PLANNING AND  
DEVELOPMENT  
SERVICES  
DEPARTMENT

Subject: Minor Amendment Request for Partners on Fourth PAD-33

Re: C9-18-01 Minor Amendment Requests  
For the Approved Multi-Use Project – COI Pad 33-  
Partners on Fourth – 4th Avenue and 8th Street

# EXHIBIT 9: PAD CONCEPT PLAN

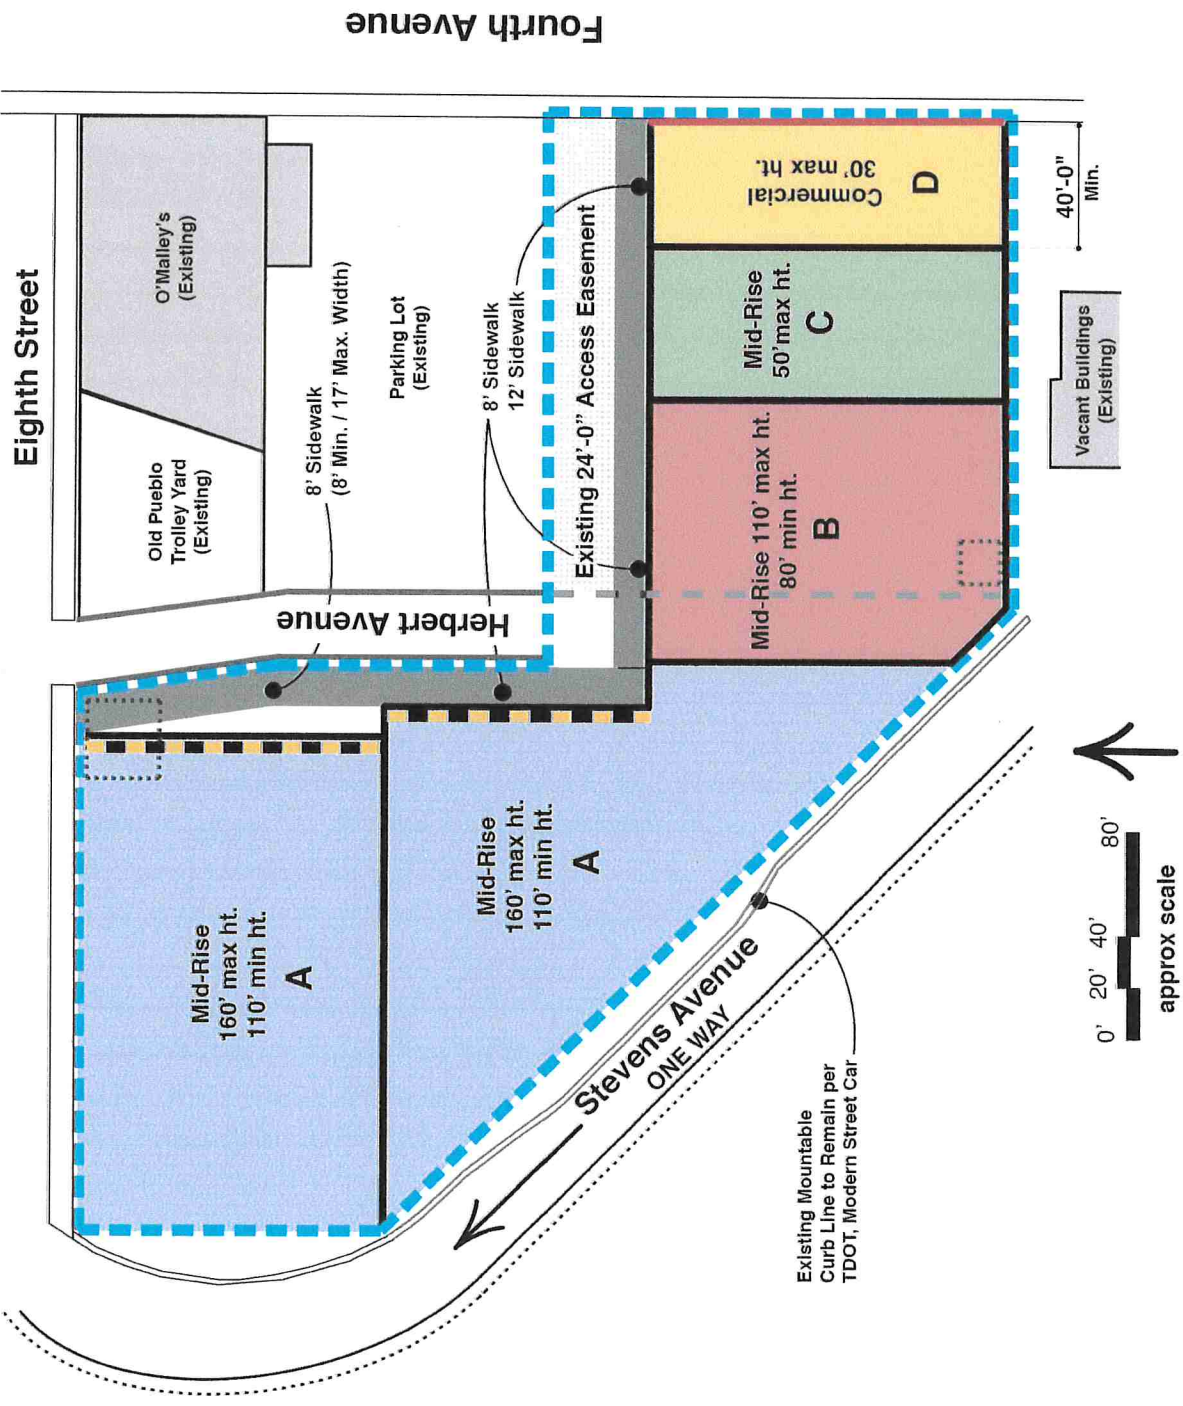
**Item 1 *Sidewalk Widths:*** You have requested a minor amendment to decrease the sidewalk widths as presented in Exhibit 9: PAD Concept Plan. You propose sidewalk widths that vary from 8-foot minimum to 17-foot maximum along Herbert Avenue (north-south sidewalk), and sidewalk widths that vary from 8-foot minimum to 12-foot maximum along the east-west access easement. The intent of this request is to address the view of and within the development along the east-west access easement as well as to create a more inviting pedestrian space within the site. The PAD currently indicates on Exhibit 9: PAD Concept Plan, a minimum of 15-foot wide sidewalk along Herbert (north-south) and a 12-foot wide sidewalk along the Access Easement (east-west).

(22.) 2-06.4.9.R - Show on-site pedestrian circulation and refuge utilizing location and the design criteria in Section 7-01.0.0, Pedestrian Access, of the Technical Standards Manual. Pedestrian sidewalks along the access easement are shown at 7.33' in width. The PAD indicates on Exhibit 9: PAD Concept Plan a minimum 12' sidewalk in this easement area.

The East-West pedestrian sidewalk as shown on the attached revised Exhibit 9 and 10 PAD Concept Plan and the detailed "Pedestrian – Vehicle Circulation Plan" will vary between 12'-8' clearance on sidewalk width. In our stakeholder meetings it was requested that there be shade trees and landscaping along the walkway. The intent of this request is to address both the user and the view from 4<sup>th</sup> Avenue locations, in order to soften the view of the development.

(24.)2-06.4.9.S - Show existing or proposed pedestrian circulation along abutting rights-of-way. Pedestrian sidewalks along Herbert Ave are shown at 6' and 4'. The PAD indicates on Exhibit 9: PAD Concept Plan a minimum 15' sidewalk along Herbert. Pedestrian sidewalks along Stevens Ave are shown varying in width down to 2.94'. Per PAD Part III.3.E(1) a minimum 6' sidewalk is required.

The North-South Pedestrian sidewalk as shown on the attached revised Exhibit 9 and 10 PAD Concept Plan and the detailed "Pedestrian-Vehicle Circulation Plan" will vary between 8'-17'. The variance is a result of enhancing the entry way to the building to the project lobby and enhancing north - south sidewalk with landscaping along Herbert from the building entry way north to 8<sup>th</sup> Street. In addition, a convenient bicycle parking area is provided, in order to meet bicycle parking requirements. The bicycle parking is provided on the wider sidewalk area. The walkway clearance between the bicycles will not be less than 8ft.

**Condition:** Revise the PAD document on page 18 (PAD-33 Part III.1. Exhibit 9: PAD Concept Plan) to show varying sidewalk widths. Change the following sidewalk notations on the exhibit:

- Sidewalk along Herbert Avenue (north-south):  
*Varies 8-foot min to 17-foot max*
- Sidewalk along east-west Access Easement:  
*Varies 8-foot min to 12-foot max*

# EXHIBIT 10: PAD NEW CONCEPT CIRCULATION PLAN

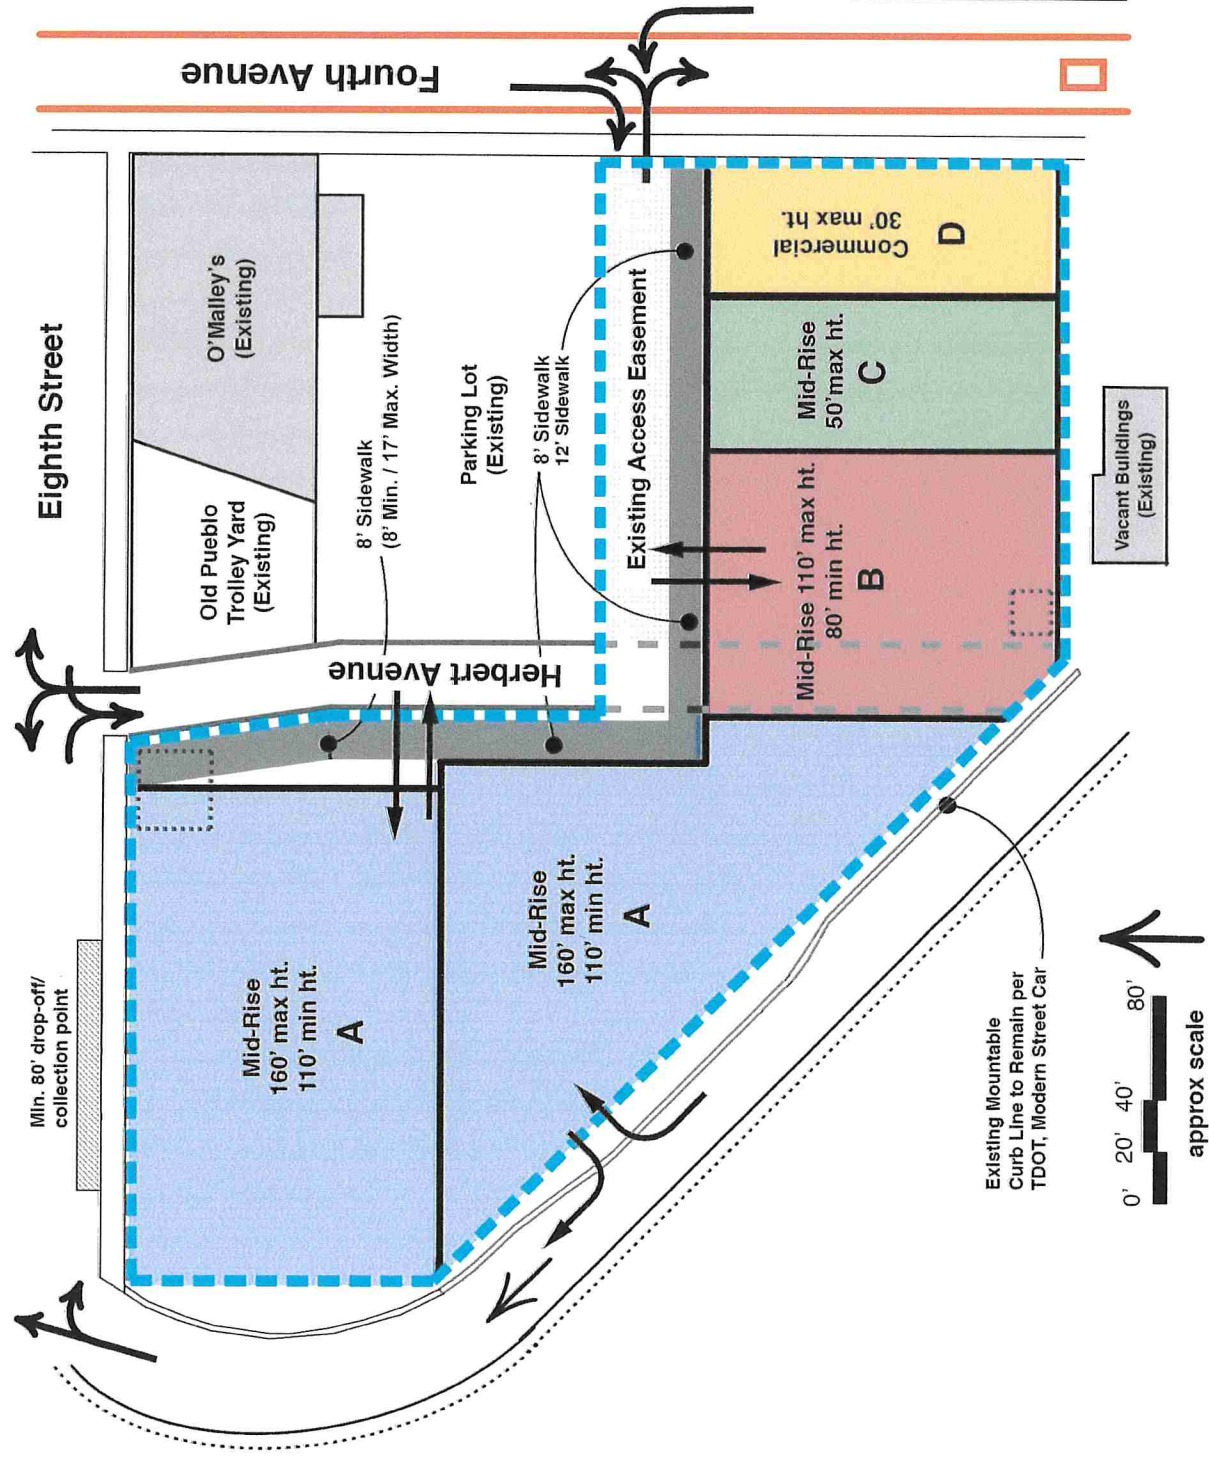
**Item 3 Circulation Plan:** In your request letter you have asked for a minor amendment to change the access points indicated in Exhibit 10: PAD New Concept Circulation Plan. In order to meet the adequate parking requirements and the appropriate life safety curb cuts on the corner of Stevens and 8th Street the request is to move access from the entrance off of 8<sup>th</sup> street, to an entrance into Section A parking garage off of Herbert Avenue and an entrance into Section B parking garage off of the east-west access easement.

(30.) Per PAD Part III.3.D(6) parking access is specifically outlined per Exhibit 10 and further mentioned in Part III.4.B. Vehicular access is not illustrated or listed along Herbert Ave or through the access easement. The submitted plan does not comply with the PAD and illustrates garage entrances on Herbert Ave and along the access easement. Additionally, PAD Part III.4.C. states points of ingress and egress shall be minimized wherever possible.

On the original design of Exhibit 10 the egress and ingress into the parking garage is very close to Stevens Avenue entering 8<sup>th</sup> Street and also allowed for a maximum of 4 drop-off vehicles. As shown on the revised attached Exhibit 10 PAD Concept Circulation Plan and the attached Pedestrian-Vehicle Circulation plan the capacity of 6 drop-off transportation can be achieved and the ingress egress of the garage located on Herbert will alleviate the additional ingress and egress on 8<sup>th</sup> Street within such a confined area. Also, again limited by the boundaries a loss of parking spaces would occur due to the lack of proper parking geometry.

A Minor Amendment is requested to allow the PAD to include the revised Exhibit 10 PAD New Concept Circulation Plan and the attached Pedestrian-Vehicle Circulation Plan in order to meet the adequate parking requirements and the appropriate life safety curb cuts on the corner of Stevens and 8<sup>th</sup> Street.

**Condition:** Revise the PAD Document to reflect the following changes

- On page 33 (PAD-33 Part III.4.B. Vehicular Access)
  - Remove
    - Ingress from Eighth Street into a surface level parking lot below the building
    - Egress from surface level parking lot below the building onto Eighth Street

- Add
  - Ingress from Herbert Avenue into Section A Parking Garage
  - Egress from Section A Parking Garage onto Herbert Avenue
  - Ingress from PAD Easement into Section B Garage
  - Egress from Section B Garage onto PAD Easement
- On page 34 (PAD-33 Part III.4.C. Exhibit 10: PAD New Concept Circulation Plan) to show proposed access changes

**Pedestrian-Vehicle Circulation Plan**  
Updated 06.26.2019

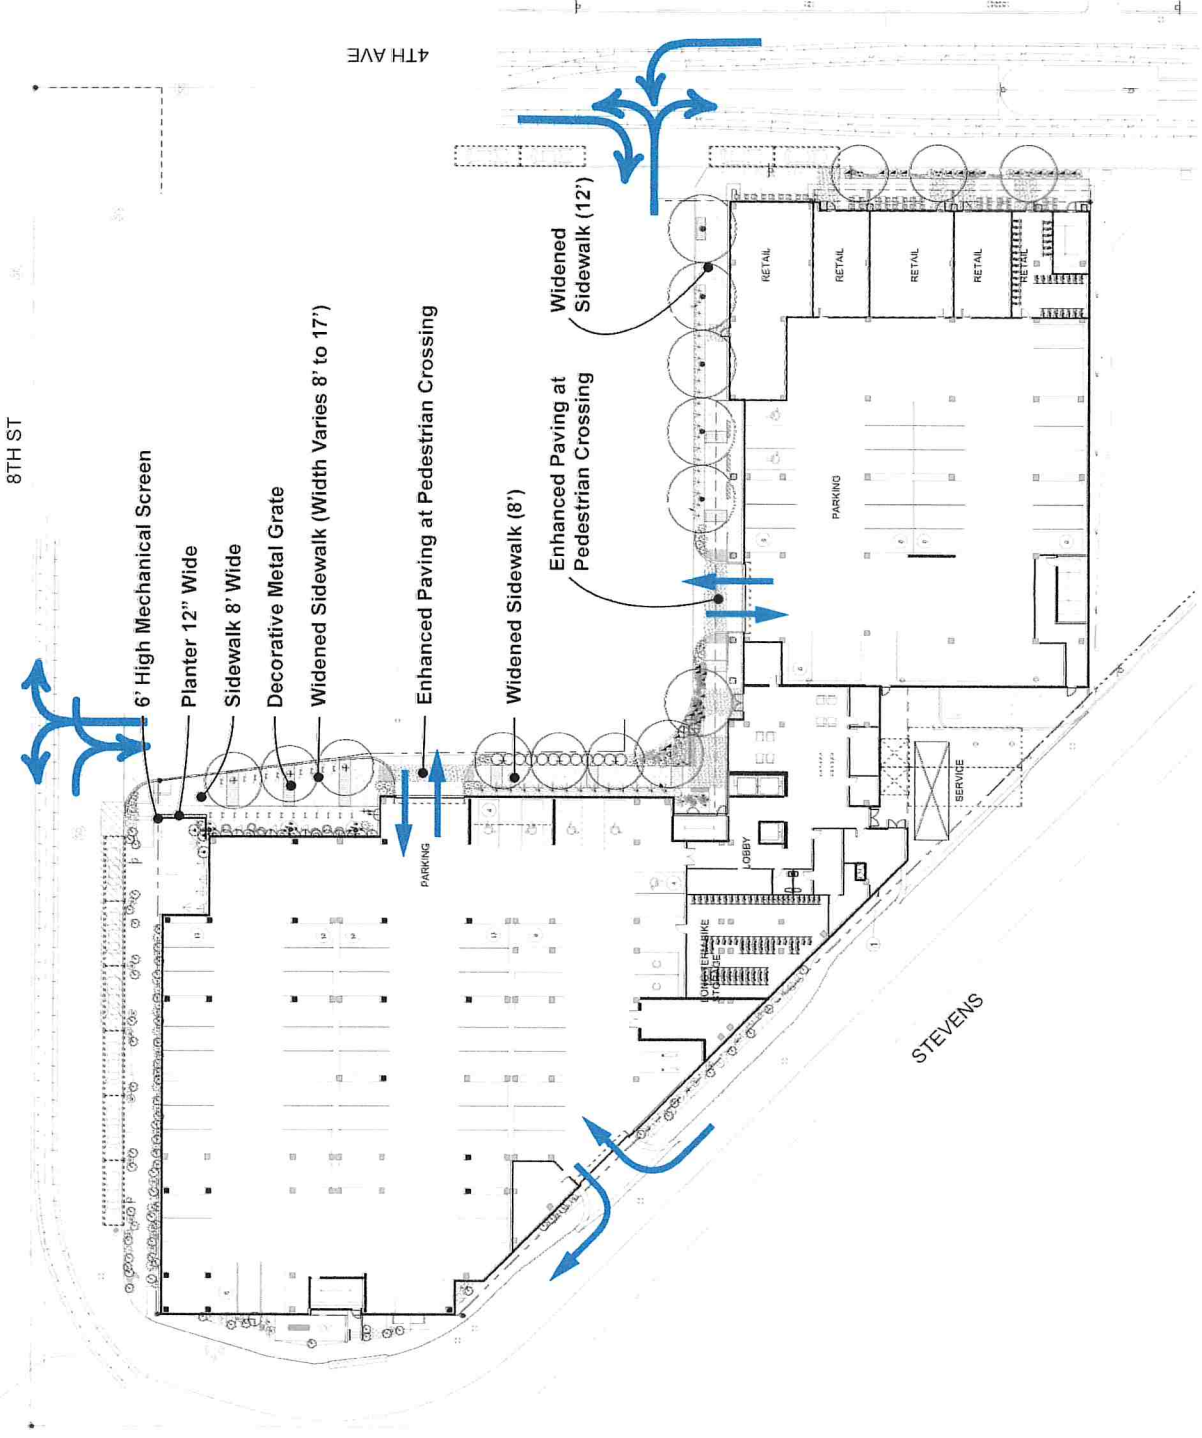
Request is for a Minor Amendment of the attached revised Exhibit 9 and 10 Concept Plan and accept the Pedestrian-Vehicle Circulation Plan and revise the design criteria in Section 7-01.0.0, Pedestrian Access.

Request is for a Minor Amendment of the attached revised Exhibit 9 and 10 Concept Plan and the acceptance of the Pedestrian-Vehicle Circulation Plan and the revision of the designed criteria in Section 7-01.0.0, Pedestrian Access.
